<b>Applicant:</b> Cedar Grove Compost Co	<b>NOC Number:</b> 11573
<b>Project Location:</b> 17825 Cedar Grove Rd, Maple Valley, WA 98038	<b>Registration Number:</b> 25994
<b>Applicant Name and Phone:</b> Ron Westmoreland (206) 450-6182	<b>NAICS:</b> 325314
<b>Engineer:</b> Madeline McFerran	<b>Inspector:</b> Corina Frost

Cedar Grove Composting Inc (Cedar Grove) is an existing commercial composting facility located in Maple Valley, WA. Cedar Grove has an existing Order of Approval (OA) 10645 which covers: the primary and secondary phases of aerated static pile (ASP) composting, the biofiltration systems treating the exhaust air from the primary and secondary ASP phases, an enclosed compost pad for yard waste and commercial food waste (Zone 7), and associated biofiltration control, In-Vessel Gore Cover Technology composting system, a tipping building with associated biofiltration control, a grinding building with associated biofiltration control, and water condensate treatment and holding tank. NOC application 11573 requests modifications to OA 10645.

This Notice of Construction (NOC) Application 11573 includes 6 specific items for review, which are grouped in three categories:

#### *Continuous Monitoring of Primary Biofilter Static Pressure*

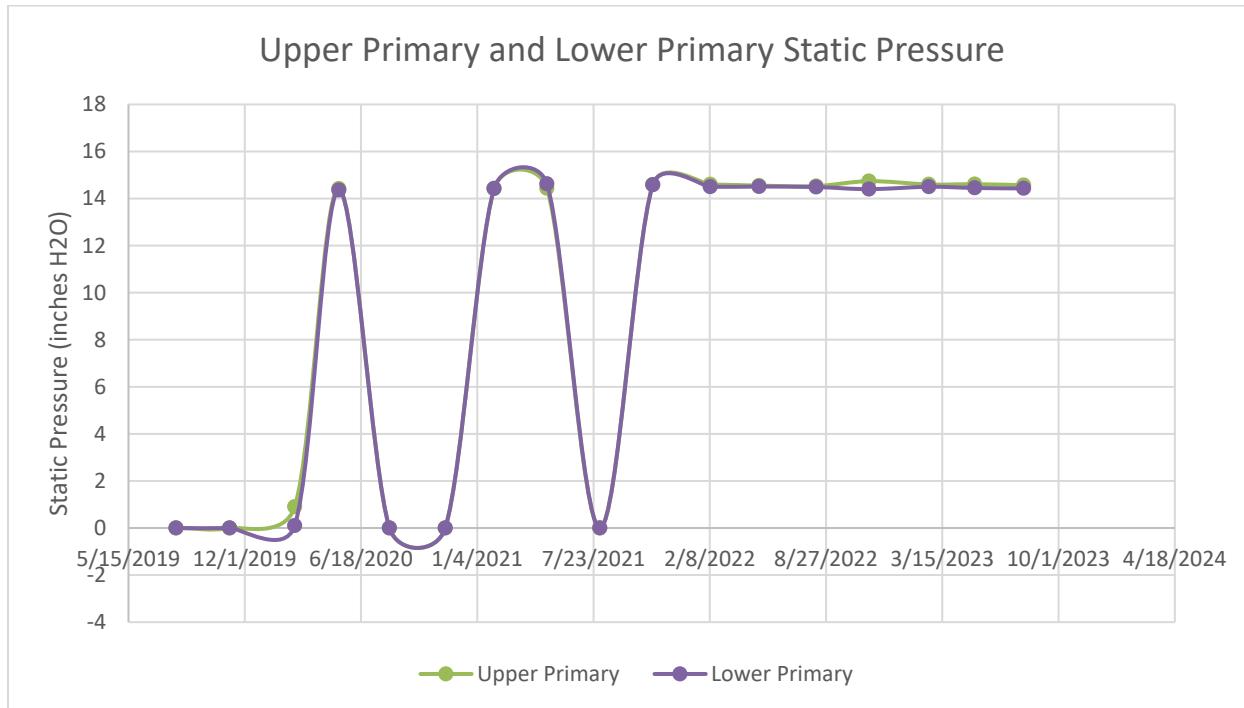
The continuous biofilter static pressure monitoring on the upper and lower primary ASPs that Cedar Grove Maple Valley reported in 2012-2014 showed that continuous monitoring of static pressure is not necessary for maintaining the biofilter media; periodic measurements are sufficient for identifying trends in the biofilter media and instigating corrective action (biofilter media replacement). The static pressure readings from the Upper and Lower Primary biofilters during quarterly evaluations from May 2019 through August 2023 are shown below. The large changes in static pressure correspond with media replacement on the lower primary biofilter in February and March of 2020 and upper primary biofilter media replacement in August 2020.
